# UNITED STATES PATENT AND TRADEMARK OFFICE

APPLICATION NO.	FILING DATE	FIRST NAMED INVENTOR	ATTORNEY DOCKET NO.	CONFIRMATION NO.
09/977,543	10/15/2001	Matthew M. Persohn	65857-0033 (01-AQP-275-VA)	1294
10291	7590	07/20/2004	EXAMINER	
RADER, FISHMAN & GRAUER PLLC 39533 WOODWARD AVENUE SUITE 140 BLOOMFIELD HILLS, MI 48304-0610			DUNWOODY, AARON M	
			ART UNIT	PAPER NUMBER
			3679

## Office Action Summary

## DETAILED ACTION

In regards to claim 32, in Figure 12 below, Funk discloses a coupling assembly comprising:

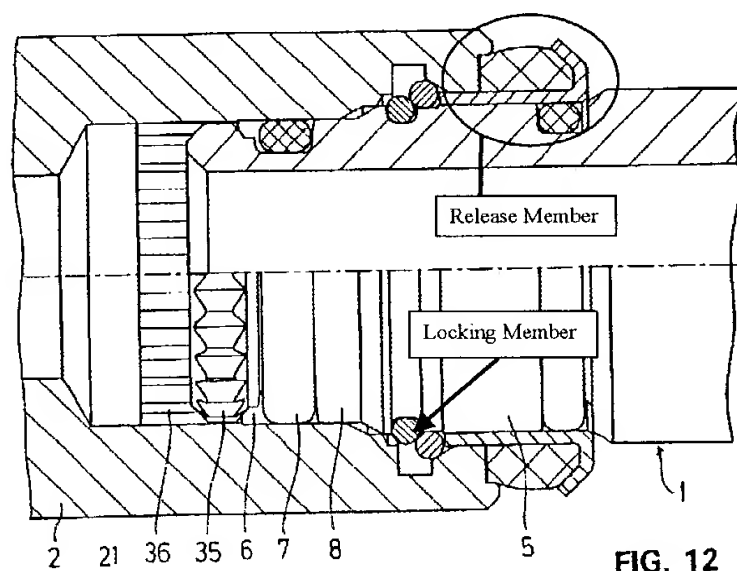
a first member (1) including a retaining formation having at least one engagement feature (35);

a second member (2) having a portion for receiving a portion of the first member, the receiving portion having at least one interior surface that includes at least one locking feature (36) configured to mate with the engagement feature of the first member to inhibit rotation of the first member relative to the second member during connection thereto; and

a locking member received in the second member. Funk does not disclose the locking member being positioned between the retaining formation and the second member when the first and second members are connected. Bizilia teaches a locking member (14) being positioned between the retaining formation

(7) and the second member (4) when the first (1) and second members are connected. As Funk and Bizilia solve the problem of coupling a first member to a second member, it would have been obvious to one having ordinary skill in the art at the time the invention was made to position the locking member between the retaining formation and the second member when the first and second members are connected, since it has been held that rearranging parts of an invention involves only routine skill in the art. *In re Japikse*, 86 USPQ 70.
